Modification To A Standard Part

502A812 THRU 845 - G07

R TRIMMED

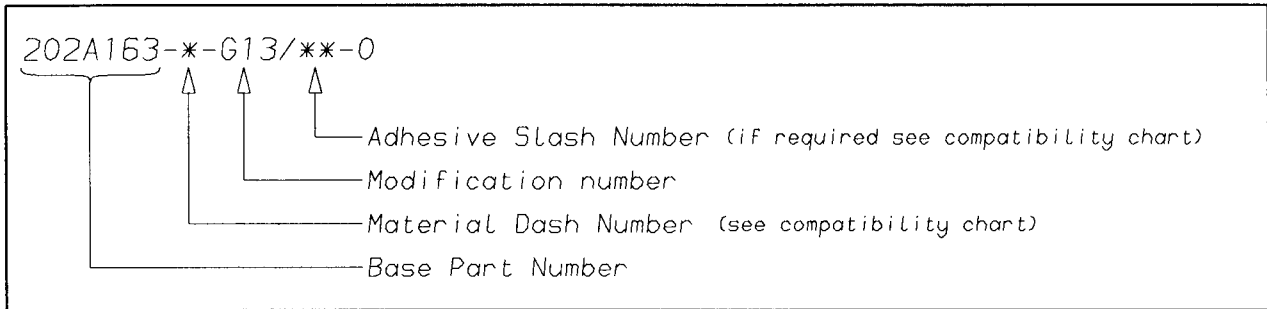
R
	+/-10%
	b
502A812	33
502A823	40
502A834	50
502A845	50

All other Dimensions Conform To Standard Product .502A812 THRU 845. . .

When coating is added, entry diameters may be reduced by 2mm max.
